Request	-	Special Use Permit for a Day Care Center/Pre-School
Location	-	611, 617, 621 Miami Street and 4, 8, 12 Nevada Street
Applicant	-	L. Hollingworth School for the Gifted & Talented 653 Miami Street Toledo, OH 43505
Owner	-	Clark Edward V. & Sharon M. Co Trustees 3156 Indian Springs Road Maumee, OH 43537
Architect	-	Kevin Young Munger Munger + Associates Architects Inc. 225 N. Michigan Street Toledo, OH 43604

The staff recommends that the Toledo City Plan Commission recommend approval of SUP-3004-23, a Special Use Permit for a Day Care Center at 611, 617, 621 Miami Street and 4, 8, 12 Nevada Street, to Toledo City Council for the following two (2) reasons:

SPECIAL USE PERMIT
TOLEDO CITY PLAN COMMISSION
REF: SUP-3004-23
DATE: May 11, 2023
TIME: 2:00 P.M.

SITE PLAN

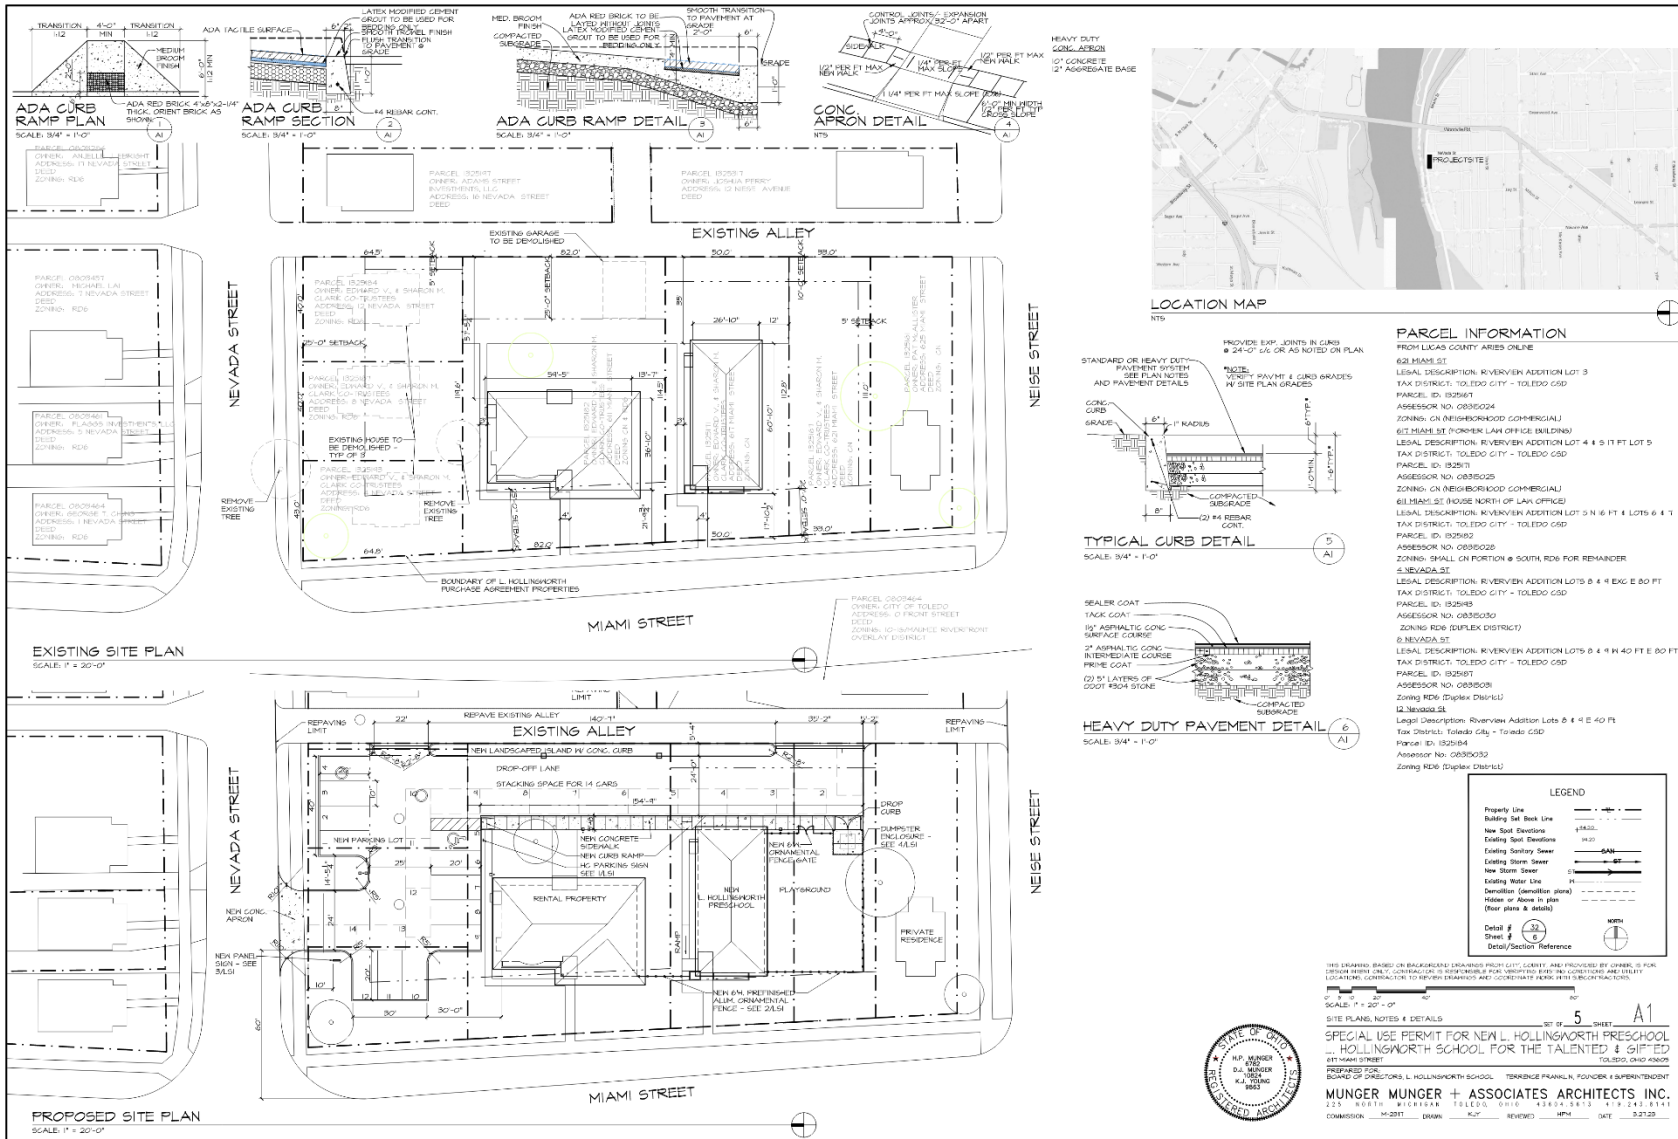
The site plan submitted depicts the outdoor play area at the side of the property (621 Miami Street) and fenced in using a six-foot (6') tall fence to screen the area. The site plan also shows ninety-five (95) shrubs and twelve (12) trees to be planted in addition to existing trees on the property. Applicant has the option to request credit for the existing trees under **TMC§1108.0407(B)**. The applicant is requesting a waiver to reduce the fifteen feet (15') greenbelt area to four feet (4') for a portion of the frontage along Nevada Avenue due to limited space. Also, the applicant is requesting a waiver from **TMC§1108.0406**, requiring landscaped areas to be irrigated as necessary to maintain plant materials in good and healthy condition. Instead, the new plant materials will be watered using tree bags until they are established.

27. Sixty (60) square feet of useable outdoor space must be provided for each person in care using the outdoor area at any one time. A Type B landscape buffer shall be provided around the outdoor space. **Not acceptable as depicted. The dimensions of the outdoor play area shall be provided on a revised site plan.**

28. Per **TMC§1107.1202(A)(1)**, parking is not allowed within the front yard in residential districts except detached houses, attached houses and duplexes where parking is allowed in the driveway. **Not acceptable as depicted on site plan. Applicant shall obtain a waiver from TMC§1107.1202(A)(1).**

29. One (1) van accessible parking space shall be required. **Not acceptable as depicted on site plan. The accessible loading aisle shall be a minimum of eight feet (8') wide.**

31. Per **TMC§1107.0900**, two (2) bike parking spaces are required. **Not acceptable as depicted. Bike parking spaces shall be shown on a revised site plan.**

LANDSCAPING PLAN

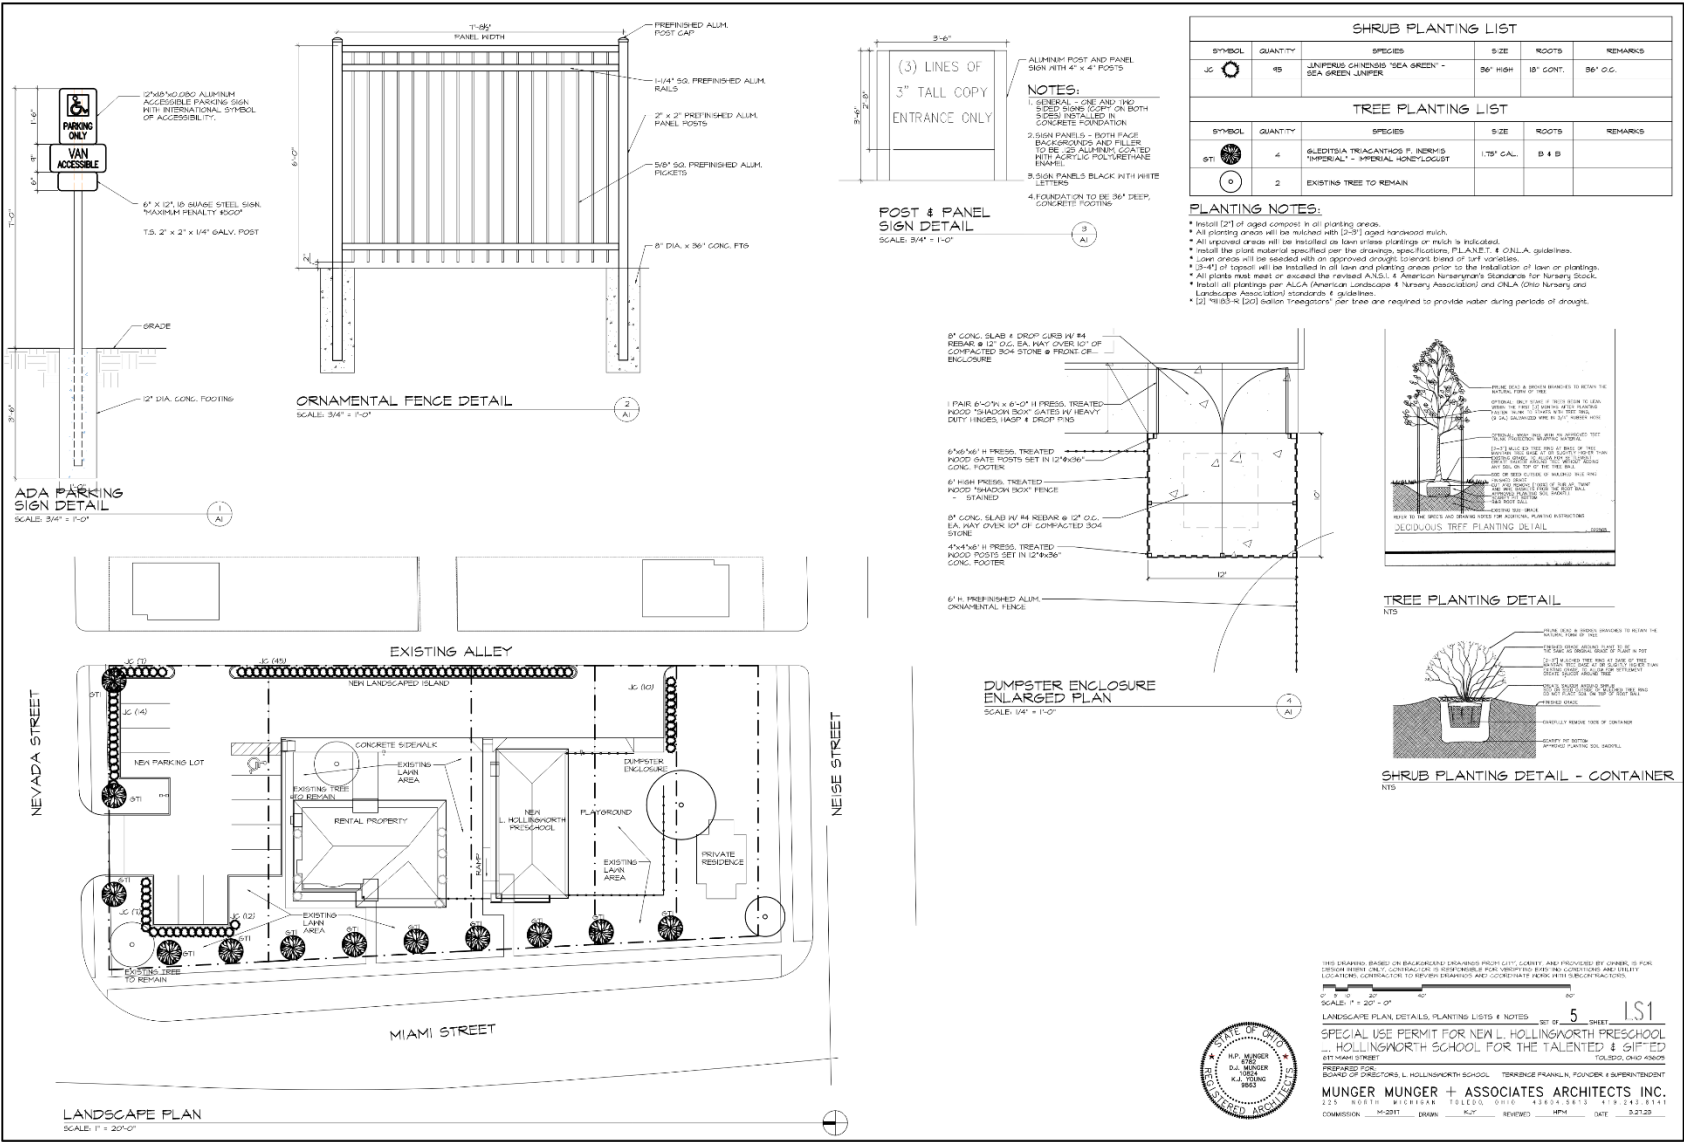
- a. Per **TMC§1108.0203(F)**, a Type B landscape buffer shall be provided around the play area. This buffer shall be a minimum of ten-feet (10') in width and consist of four (4) canopy trees and fifteen (15) shrubs installed every 100 linear feet. Pursuant to **TMC§1108.0203(D)(2)**, a fence, wall, or berm six-feet (6') to eight-feet (8') in height may be used and can substitute for the shrub requirements. Applicant has the option to request credit for the existing tree under **TMC§1108.0407(B)**. **Acceptable as depicted on site plan.**

- b. A fifteen-foot (15') greenbelt is required along Miami Street and Nevada Avenue. Nine (9) new and two (2) existing trees are indicated on Miami Street within an eighteen-foot (18') greenbelt which is compliant. There are three (3) trees and twenty-one (21) continuous shrubs indicated along Nevada Avenue in a four-foot greenbelt area. **Not acceptable as depicted on site plan. Applicant shall obtain waiver from TMC§1108.0202(B)(3).**

- f. **Per TMC§1105.0302(A)**, fences may not exceed three and a half feet (3½') in height in the required front setback. **Not acceptable as depicted on site plan. Applicant shall obtain a waiver from TMC§1105.0302(A).**
